BURLINGTON DEVELOPMENT REVIEW BOARD

PUBLIC HEARING NOTICE

- 1. 15-0338PD: 112-114 ARCHIBALD STREET (NMU, Ward 2) Champlain Housing Trust, Inc.**
15-0341PD: 27 BRIGHT STREET (NMU, Ward 2) Champlain Housing Trust, Inc.
15-0342PD: 35-39 BRIGHT STREET (NMU, Ward 2) Champlain Housing Trust, Inc.
15-0343PD: 47 BRIGHT STREET (NMU, Ward 2) Champlain Housing Trust, Inc.
Final Plat Review to demolish 3 existing residential buildings (retain the duplex at 27 Bright Street) and construct four new residential buildings for 42 new units (total of 44 units) with associated site improvements.

- 2. 14-1030SN: 87 KING STREET (RH, Ward 5) King Street Youth Center**
Appeal of administrative permit denial of sign for King Street Center.

North Elevation 1/8" = 1'-0"

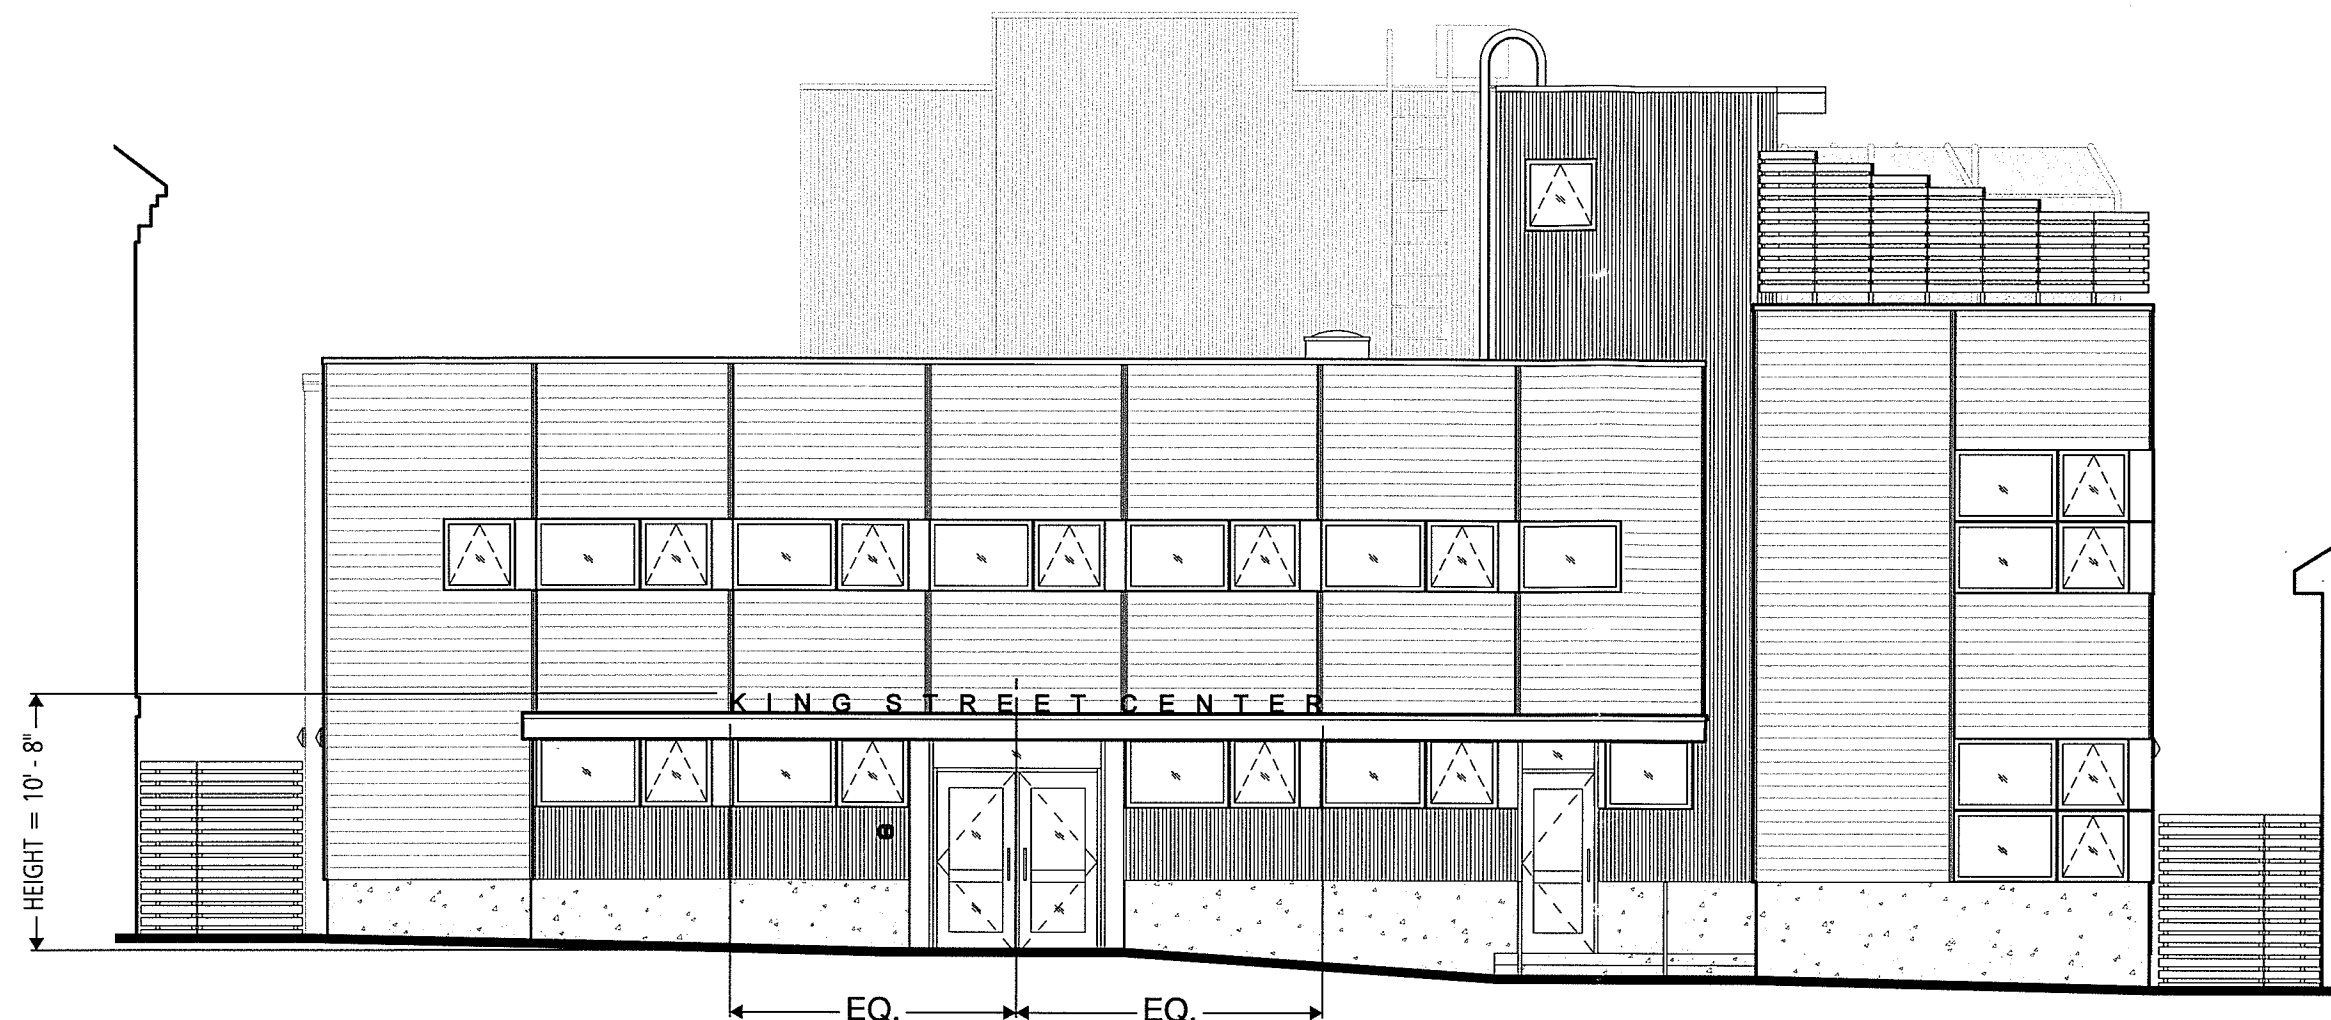
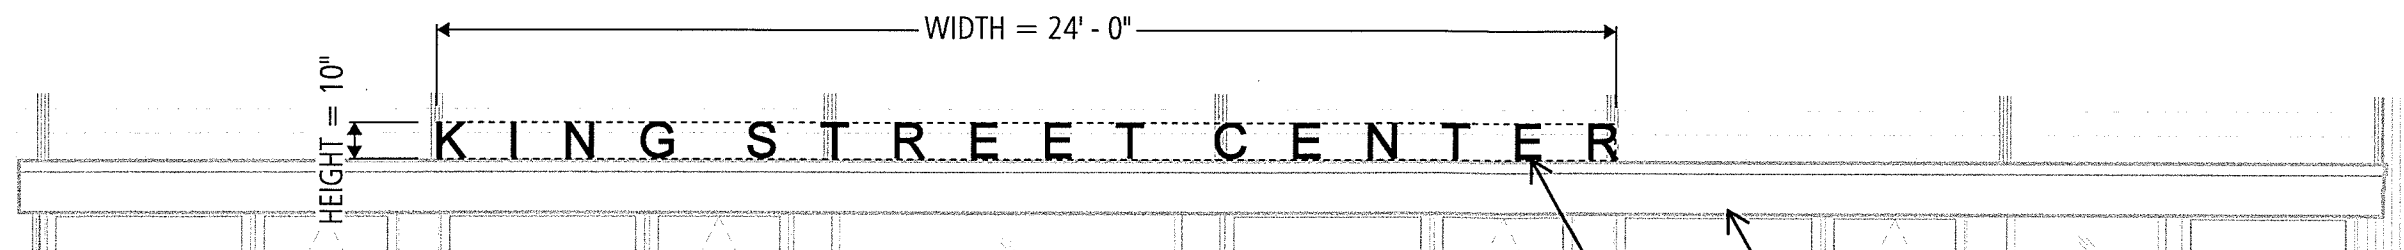
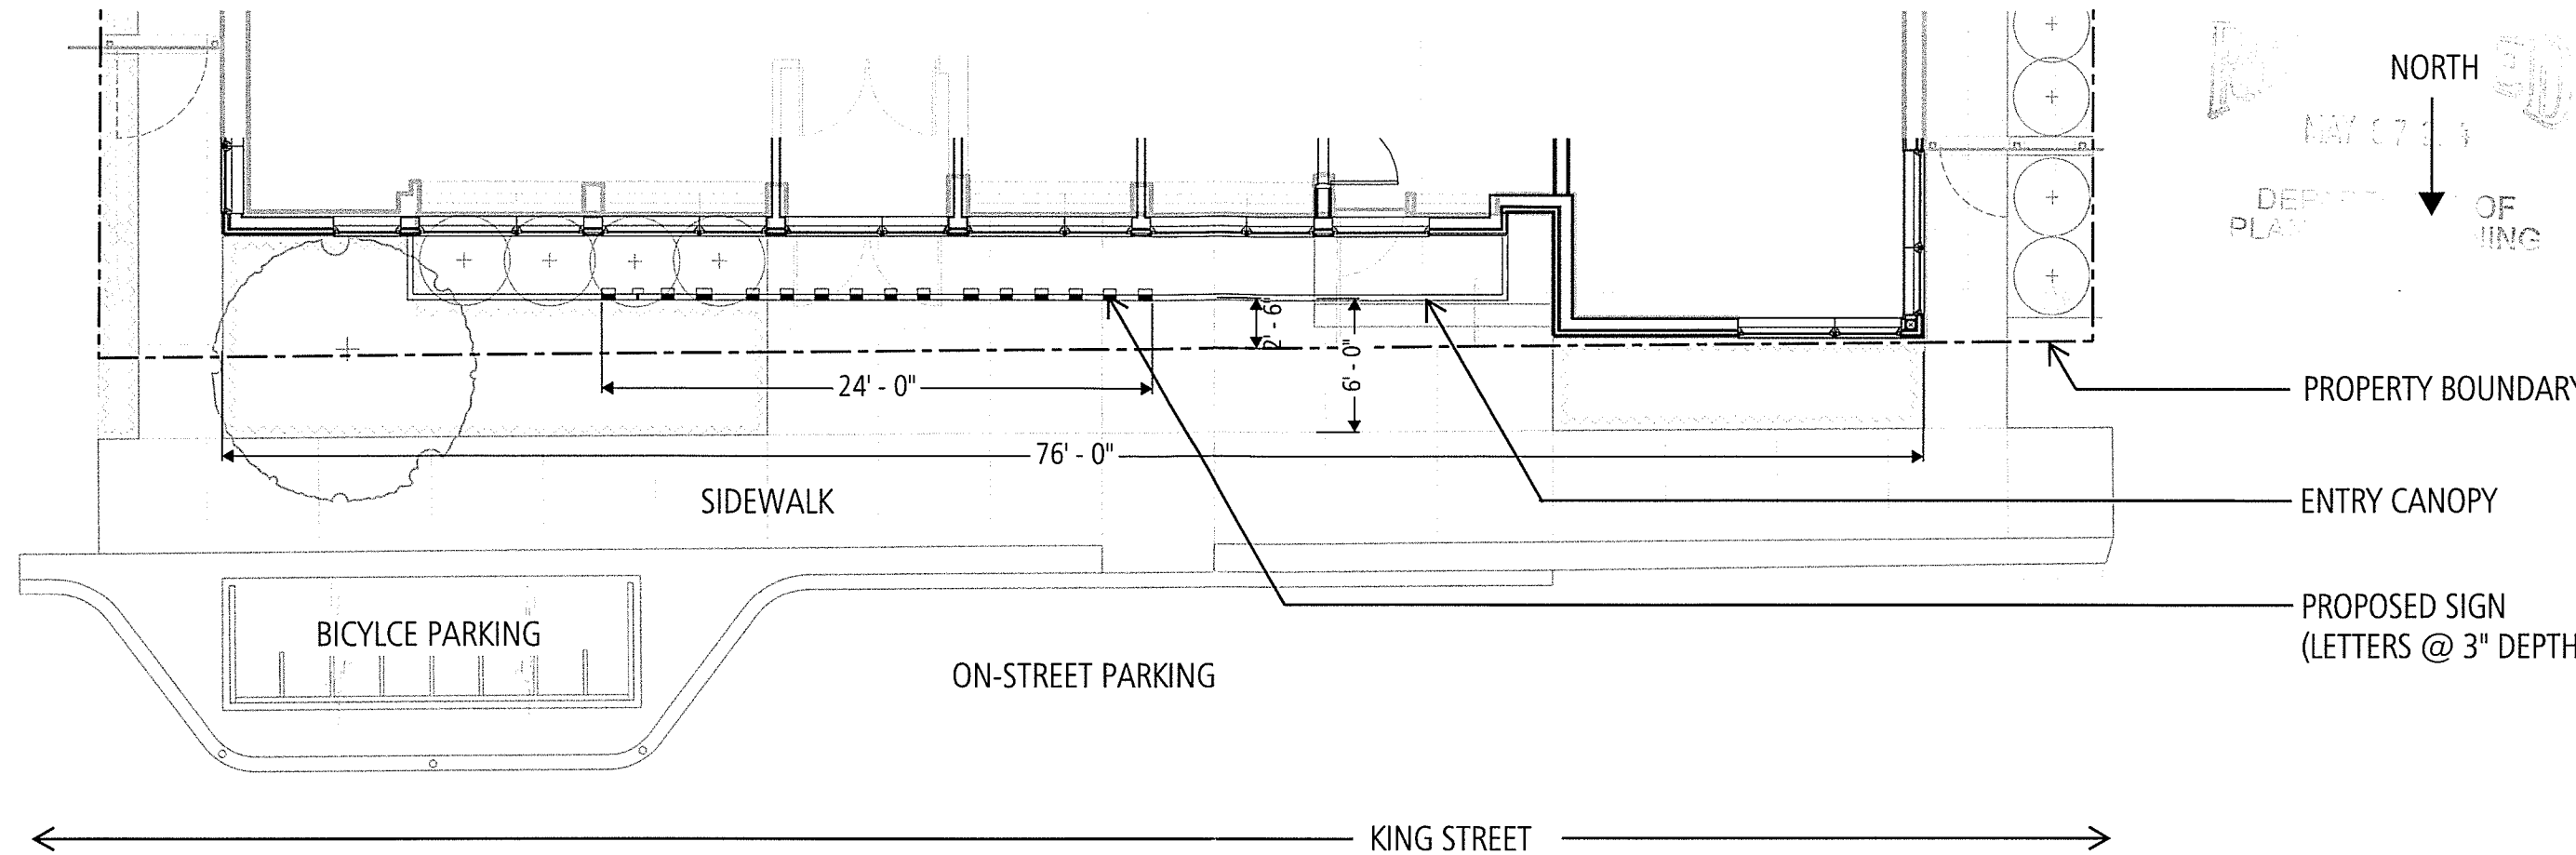
It is uncontested that the proposed sign is dimensionally compliant and largely consistent with the standards for signs in the residential districts (the property is located in the High Density Residential zone). It is not, however, consistent with Sec. 7.1.9 (c). This section would indeed prevent signs that project above the uppermost parapet and/or roof of a structure. This section also prevents parallel signs from projecting “...beyond the edge of any wall or other surface to which it is mounted” (emphasis added). In this case, the proposed sign would be located entirely above the canopy face to which it would be mounted.

While the proposed sign is not aesthetically objectionable, it simply does not comply with the restrictions of Sec. 7.1.9, *Types of Signs* (c) *Parallel Signs*. The proposed lettering could be lowered onto the face of the canopy. If need be, the canopy could be modified to provide a wider face behind the lettering to prevent any projection of the sign.

Let me know if you have any questions. I'll hold onto the application pending receipt of a revised sign location.
Scott

Job Name: Bright Street Cooperative
Burlington, VT
Lighting Layout

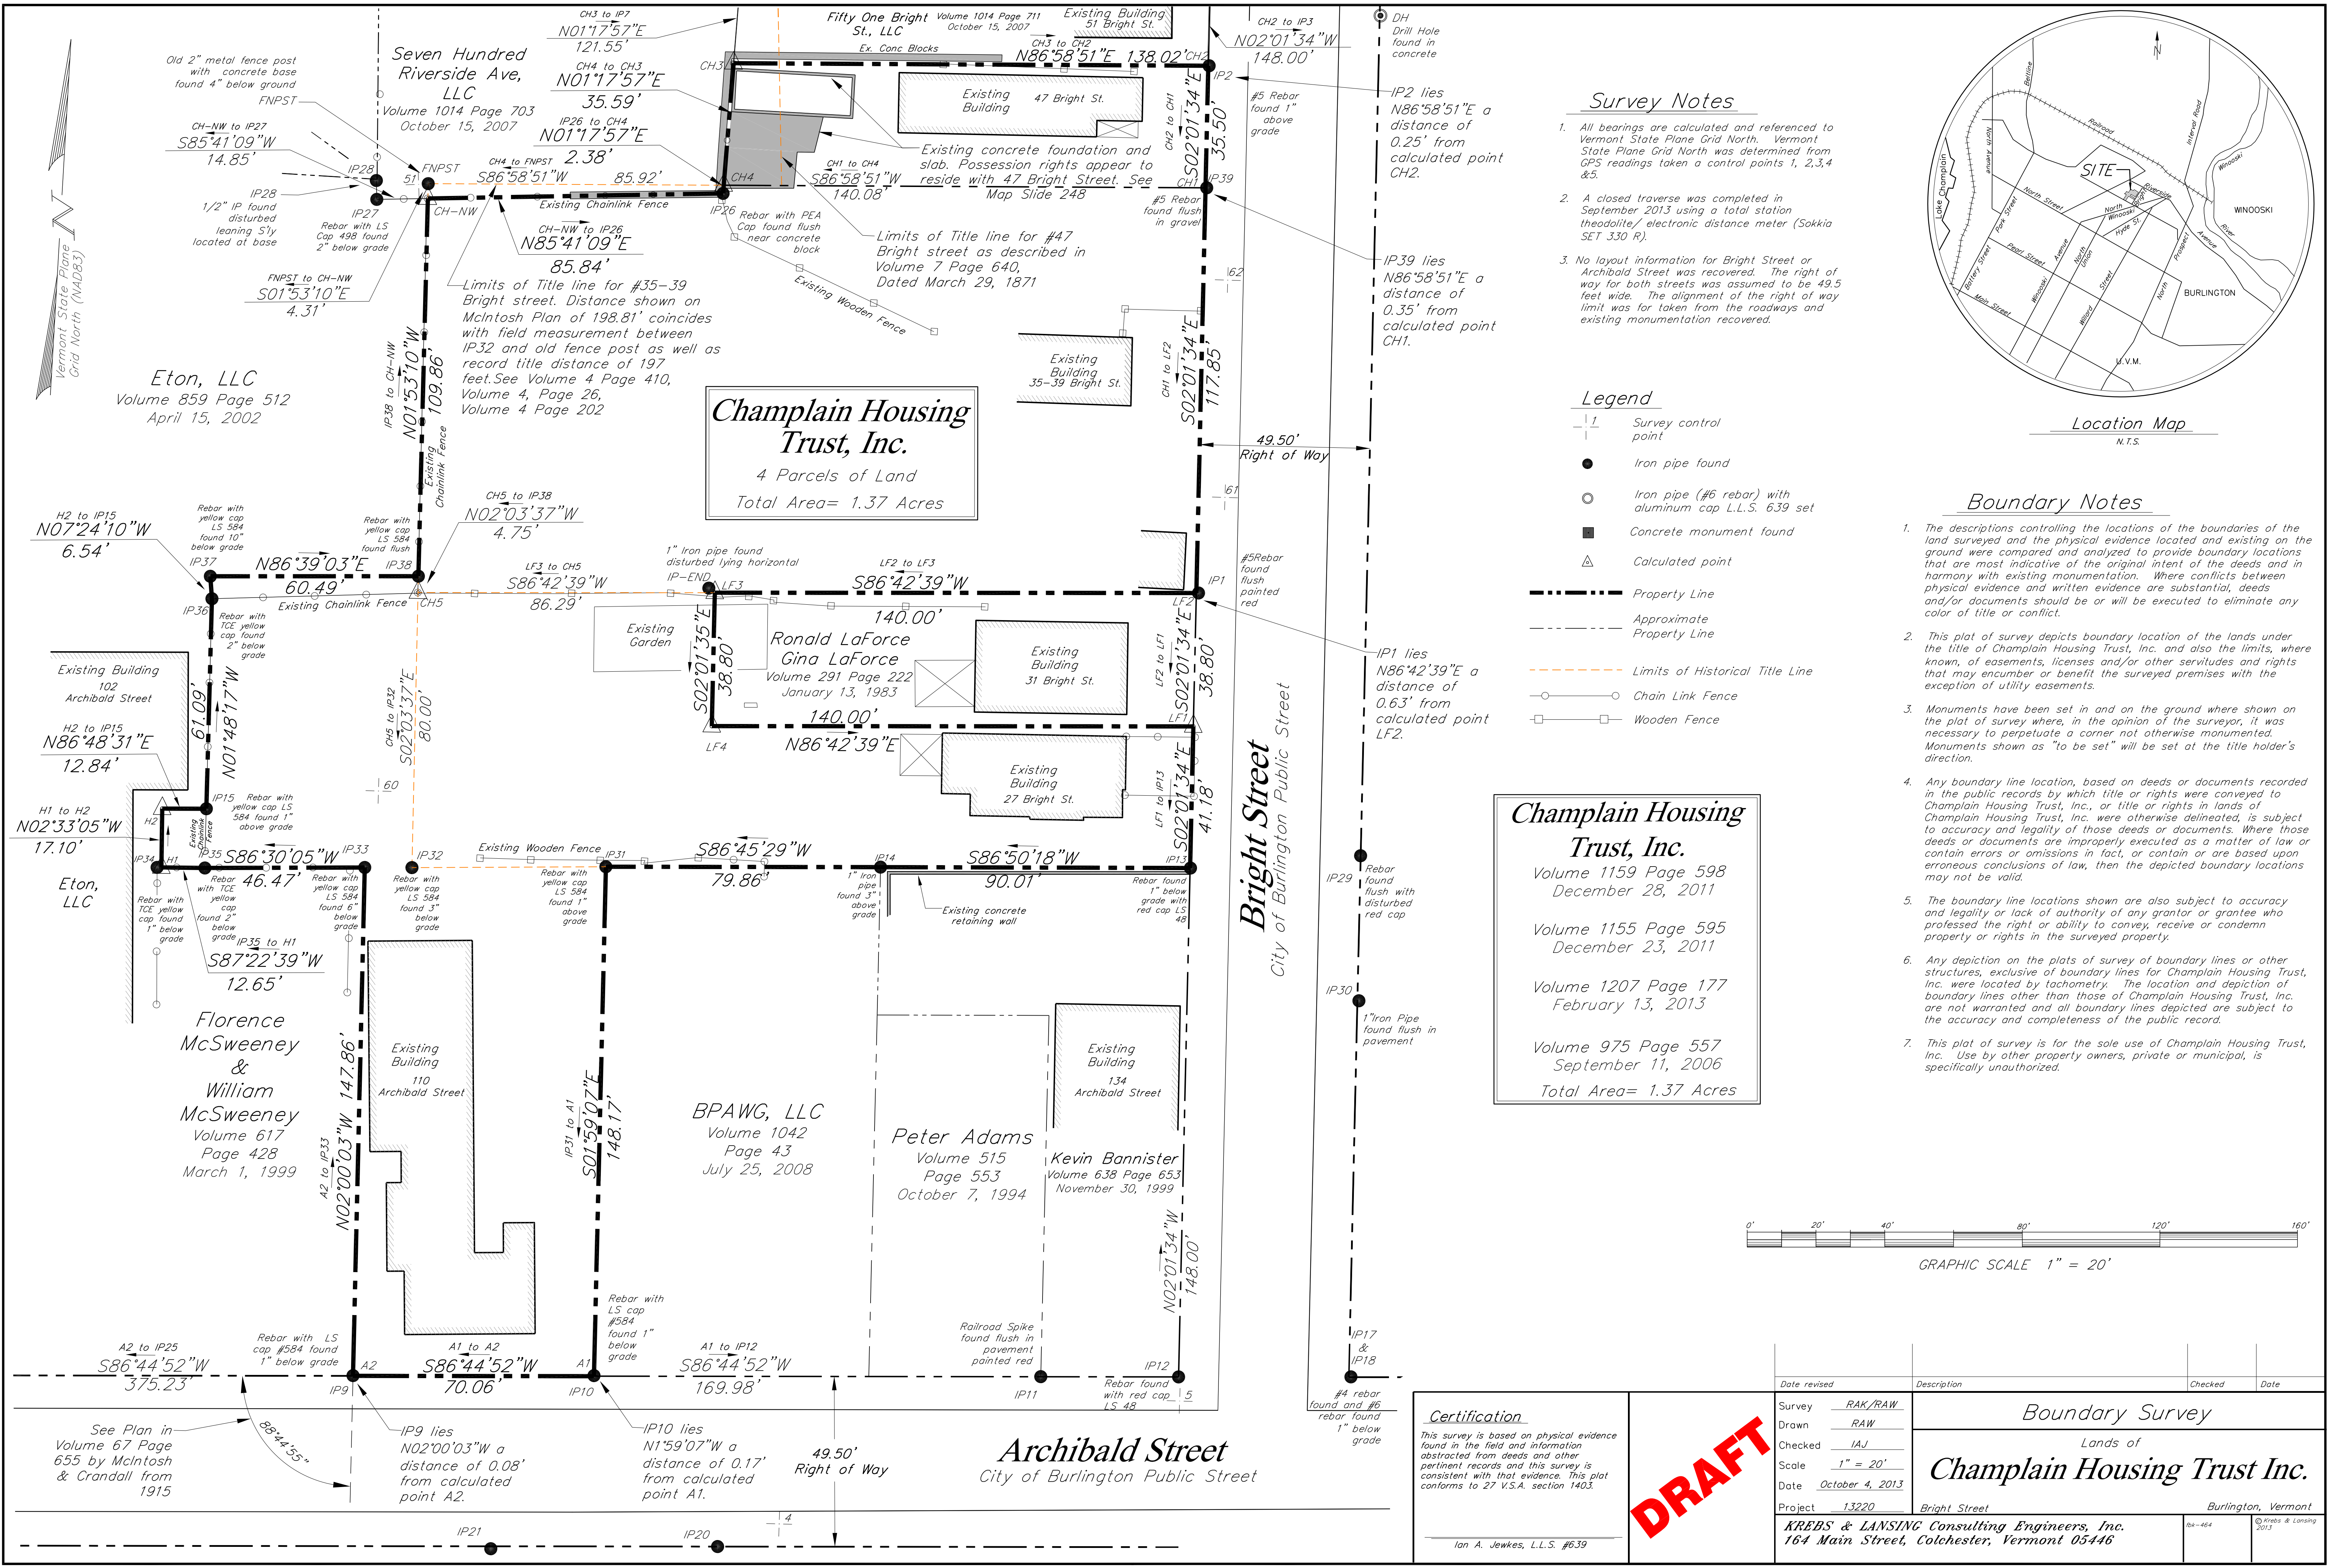
3. Lighting at building entrances exceeds standards of the *Outdoor Lighting Manual for Vermont Municipalities*, Table 2, p. 10: *Building Entry – active use, 5 footcandles average maintained*. Measurements on the lighting plan illustrate entryway lighting between 5.1 fc (duplex 2 on Archibald Street) to 8.7 fc (Trinity east entrance.) All building entrances exceed the 5 footcandle limitation, and will require revision to meet these standards, or confirmation that the average maintained level meets the standard.

Lighting at building entrances has been revised downward; however, illumination levels at several building entries exceed the 5.0 footcandle maximum noted in the *Outdoor Lighting Manual for Vermont Municipalities*, Table 2, p. 10: *Building Entry – active use, 5 footcandles average maintained*. Entryway lighting must be revised so as to not exceed this 5.0 footcandle maximum

5. **Prior to release of the zoning permit**, a revised photometric plan shall be submitted that depicts illumination levels of 5.0 footcandles or less at all building entries (not including the underground garage), subject to staff review and approval.
